## Product Change Notice (PCN)

**PCN Number:** PCN-0451320R-01

**Product(s) Affected:** PDP-30

**Description of Change:** housing and materials changes as shown below.

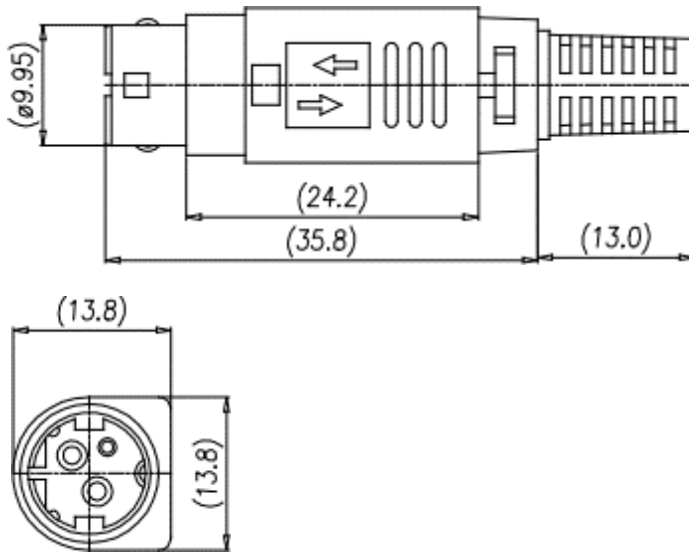
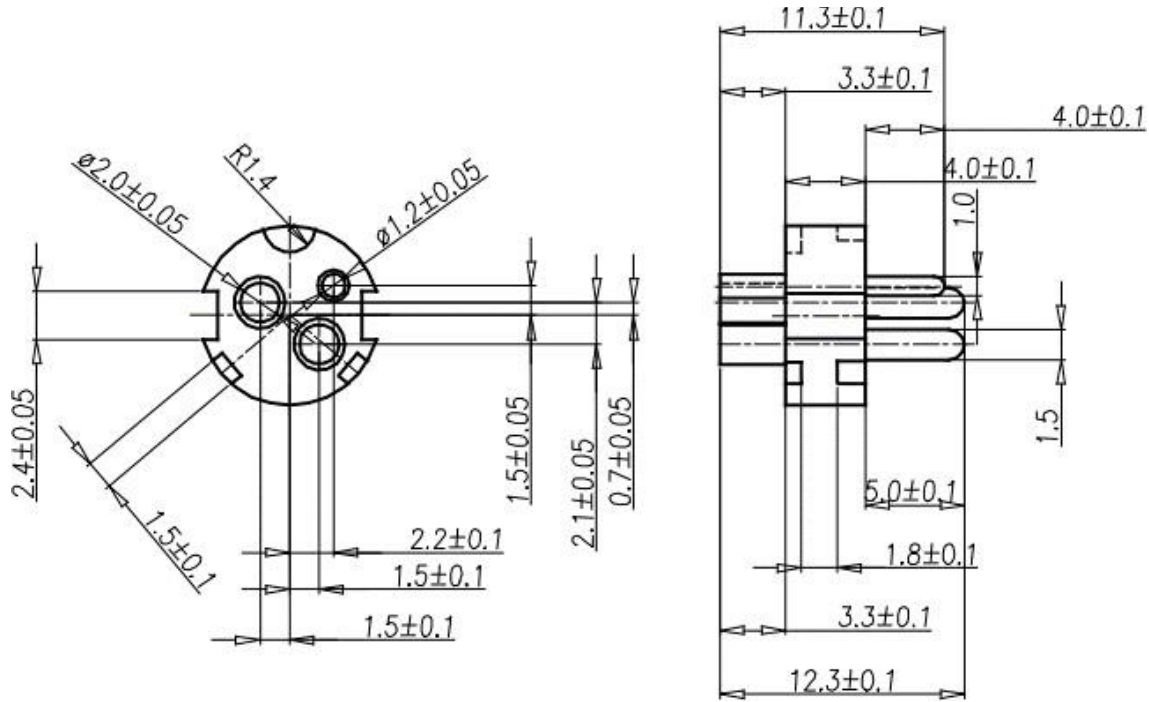
**Reason(s) for Change:** manufacturing build location change.

**Old design materials**

MATERIAL	PLATING
OUTER HOOD	ABS	
METAL SLEEVE	Brass	Nickel
CLAMP	Brass	Nickel
PIN/BODY	Brass/PBT	Silver
PLASTIC RING	POM	
METAL COVER	Brass	Nickel
SPRING	Steel	
INNER HOOD	ABS	
STRAIN RELIEF	PVC

**New design materials**

MATERIAL	PLATING
housing	PBT (UL94V-0)	
contacts	copper alloy	silver
plastic cover	ABS	
metal shell	copper alloy	nickel
metal cap	copper alloy	nickel
cable fixer	copper alloy	tin
ring	POM	
spring	steel	nickel
plastic tube	ABS	
SR	PVC
